Rainforth Grau Architects Project No. 2015-1225.00
 DSA File and Application No. 34-53/02-115661
 PTN: 67439-338

ADDENDUM NO. 01

Sutter Middle School - HVAC Replacement
 Sacramento, California

Unit A1 Foodservice Plan - E4.1.6
 SUTTER MIDDLE SCHOOL - HVAC
 REPLACEMENT
 SACRAMENTO CITY UNIFIED SCHOOL DISTRICT
 SACRAMENTO, CA
 DSA APP.02-115661 FILE NO. 34-53

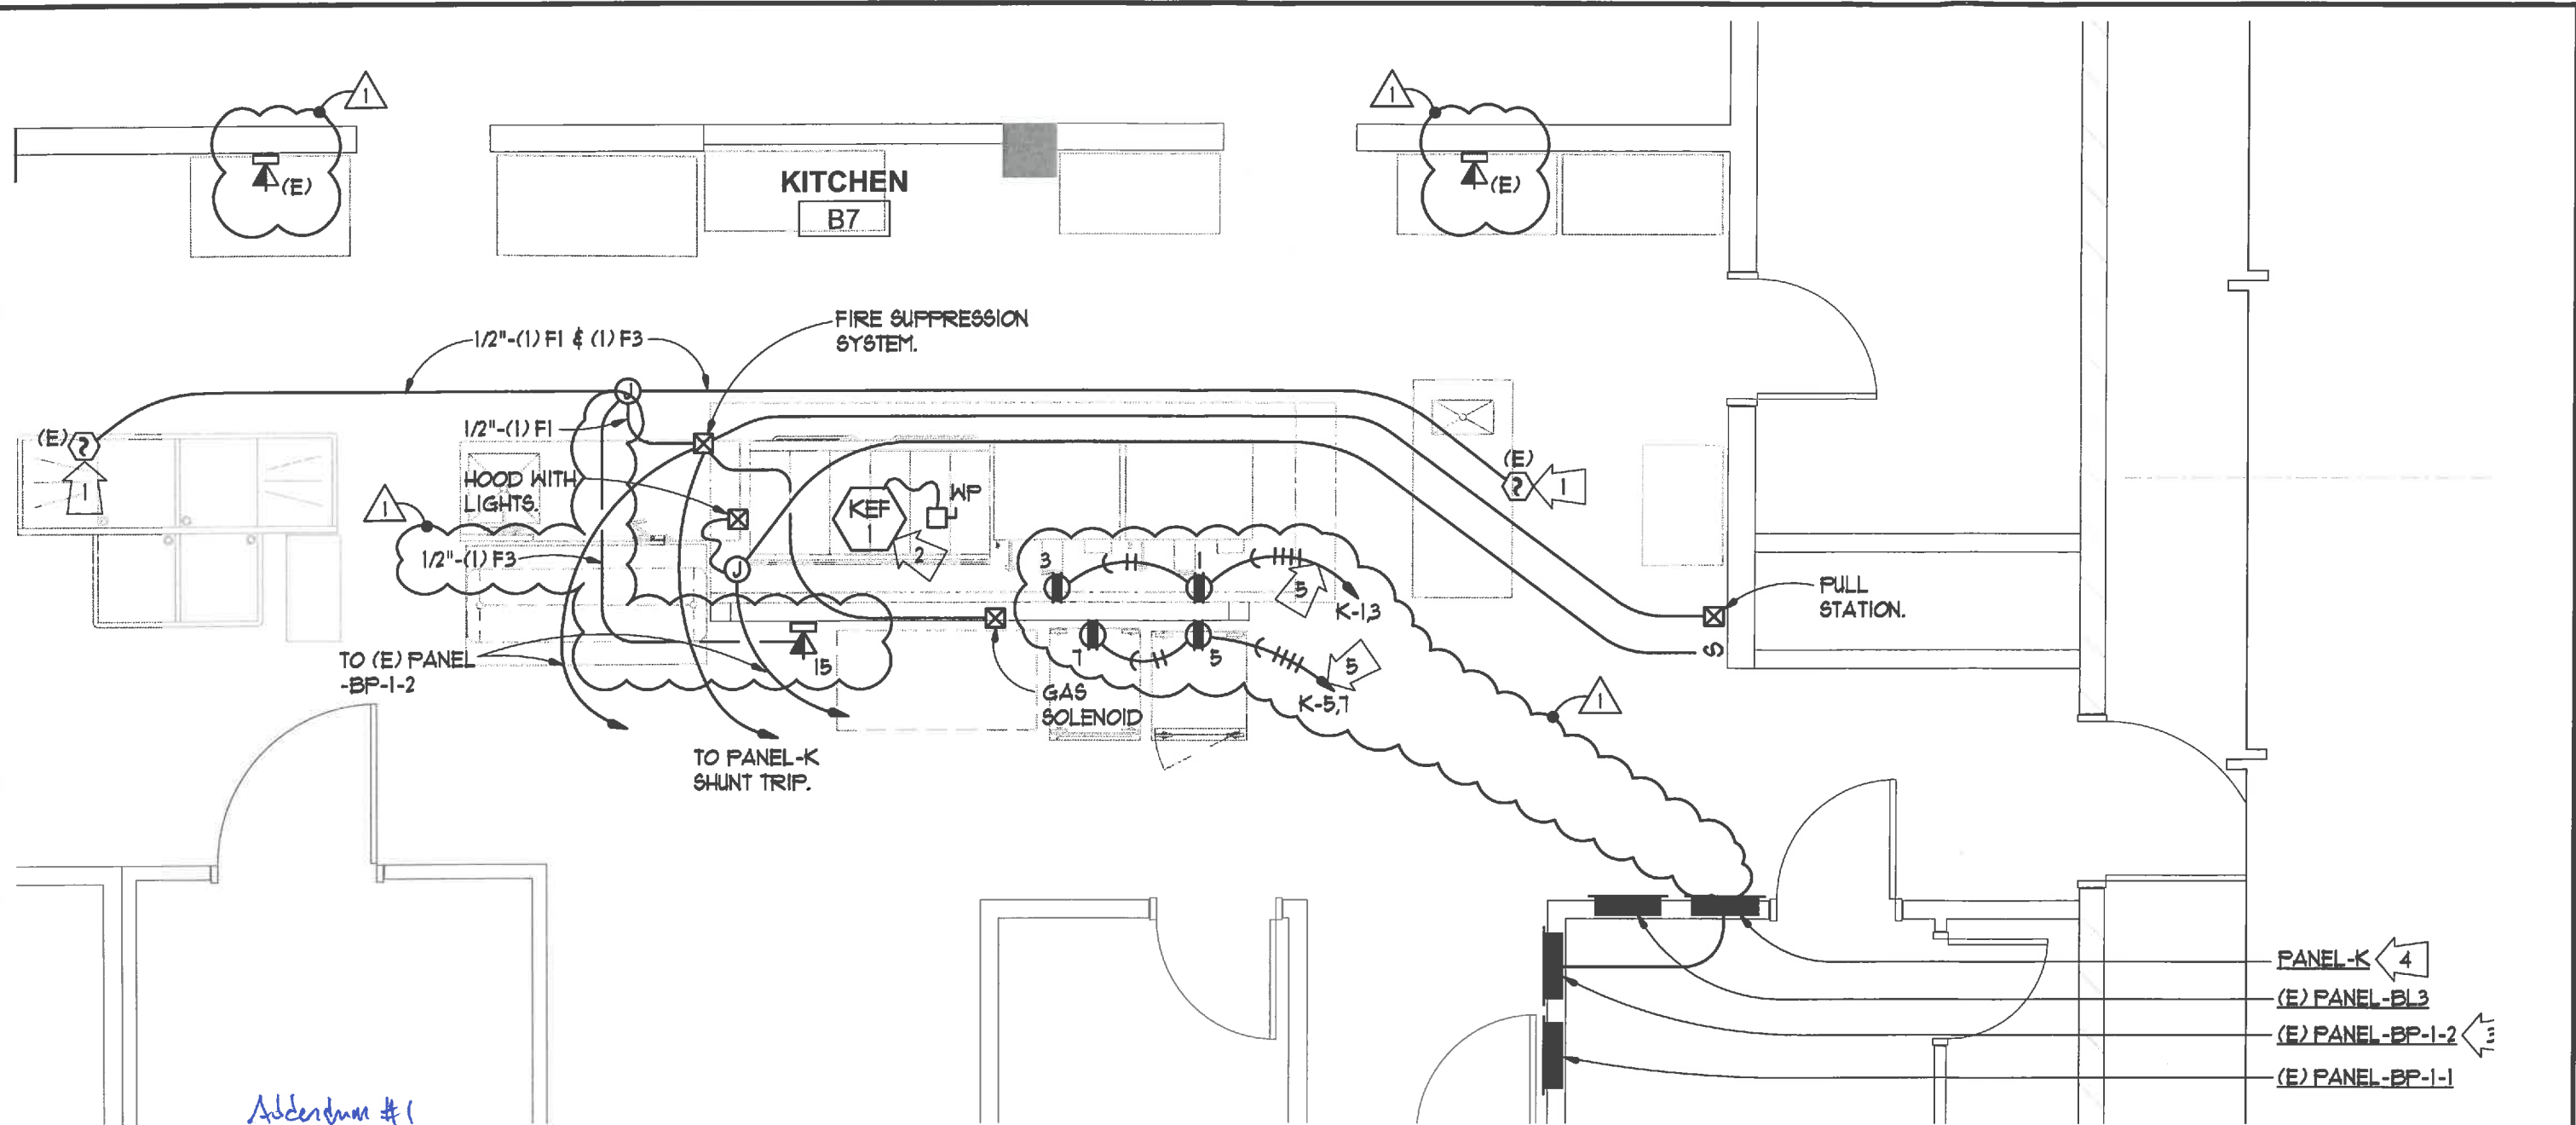
- U. Sheet E4.1.6, Unit A1 – Food Service, Electrical Floor Plan
1. REVISE this sheet per drawing AD1.17 included with this addendum.
- ~~V. Sheet E5.1.1, Fire Alarm Schedules, Calculation & Diagrams~~

Electrical Schedules - E6.1.1

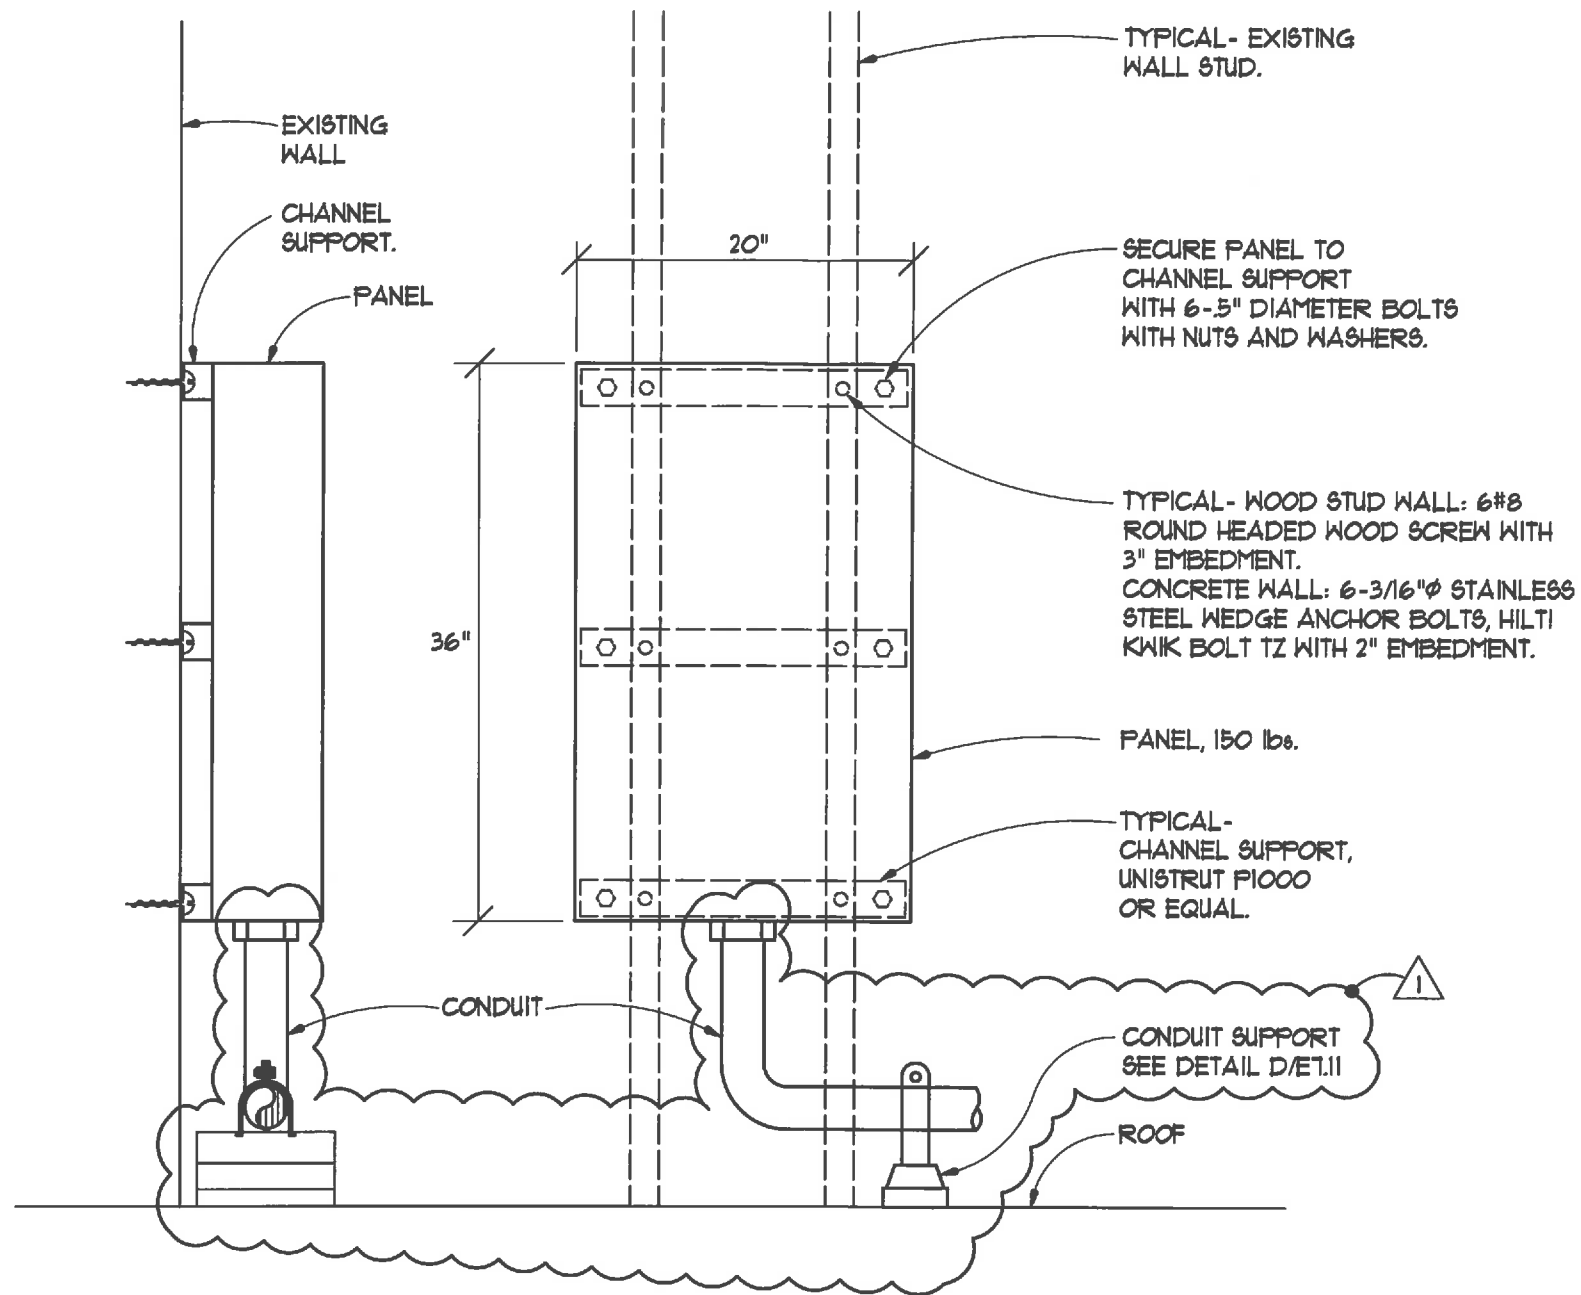
- ~~1. DELETE this sheet in its entirety and REPLACE with drawing AD1.18 included with this addendum.~~
- W. Sheet E6.1.1, Electrical Schedules
1. REVISE this sheet per drawing AD1.19 included with this addendum.

A LIGHT FIXTURE MOUNTING DETAILS
E7.1.2 NO SCALE

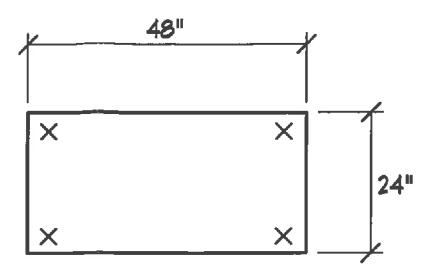
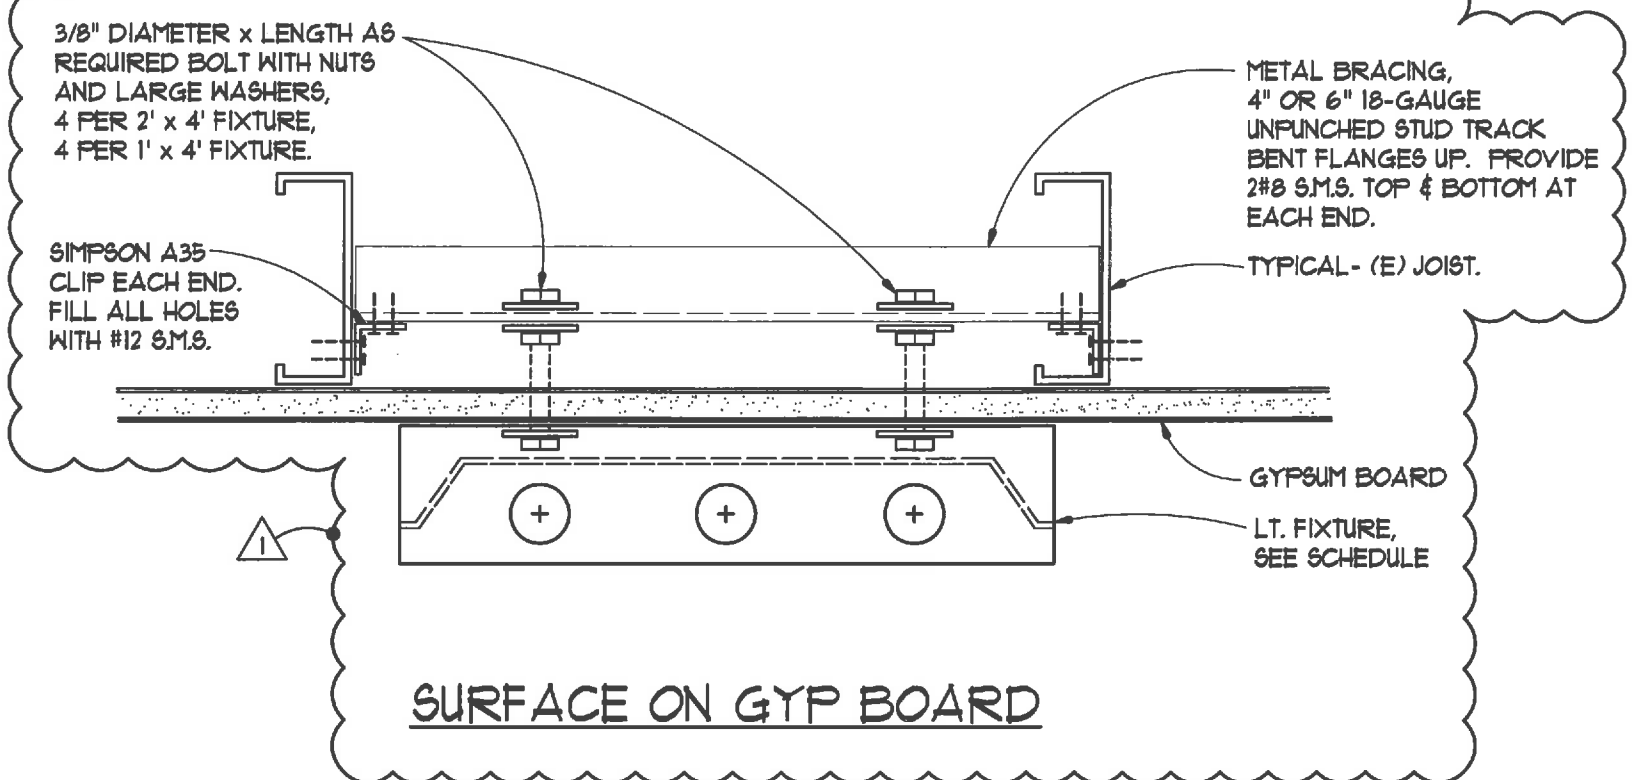
2. DELETE Detail C, Panel Mounting Support Detail in its entirety and REPLACE with Detail C/E7.1.1 per drawing AD1.21 included with this addendum.
- Y. Sheet E7.1.2, Light Fixture Schedule, Notes and Details
1. REVISE Detail A, Light Fixture Mounting Details per drawing AD1.22 included with this addendum.
